**BEFORE THE WHANGAREI DISTRICT COUNCIL AND NORTHLAND REGIONAL
COUNCIL**

IN THE MATTER of a resource consent application by Northport
Limited under section 88 of the Resource
Management 1991 for a port expansion project
at Marsden Point

**REBUTTAL STATEMENT OF EVIDENCE OF BRUCE BLAIK GOODCHILD
(NAVIGATION SAFETY)**

3 October 2023

Figure 1: Illustration of possible tug design

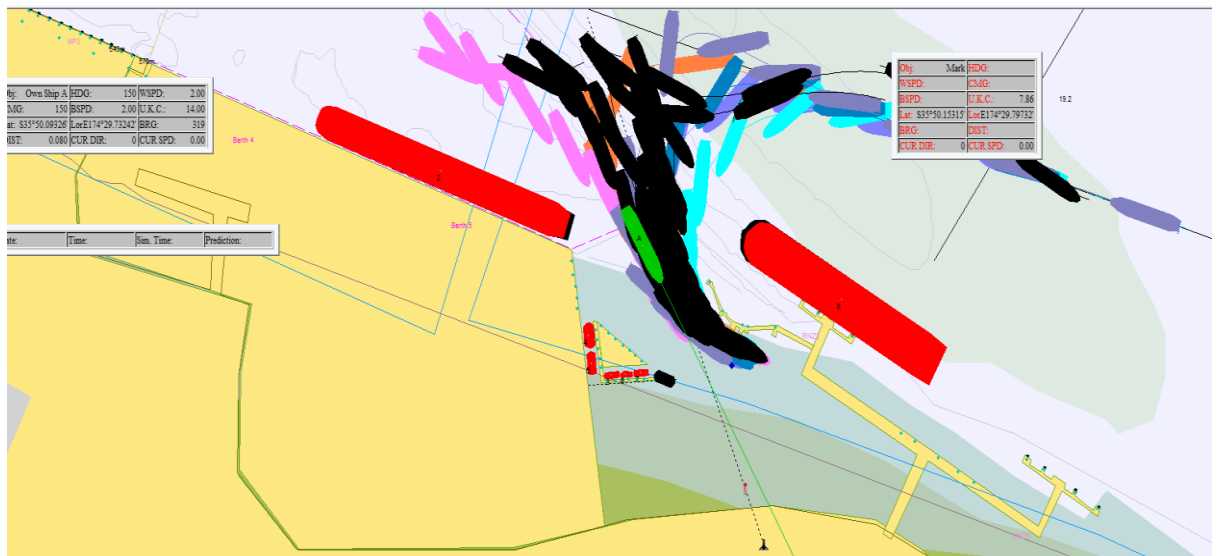
24. Paragraph 5.6 (c): This paragraph is incorrect and misleading. The detailed design of the tug facility will be undertaken having consideration to factors including tug requirements at the time, and what ship(s), if any, are using Jetty 3. I agree that any final design of the tug facility will need to be clear of any track envelopes for tankers operating in Jetty 3. For clarify however, I repeat that in my view the simulations undertaken showed that safe operation of a suitably designed tug facility can be achieved. In Figure 1 below for illustrative purposes is another possible tug design clear of the manoeuvring area for Awanuia. I consider that the references in Mr Arbuthnot’s evidence to contact with the tug facility, and ships running aground, are misleading.
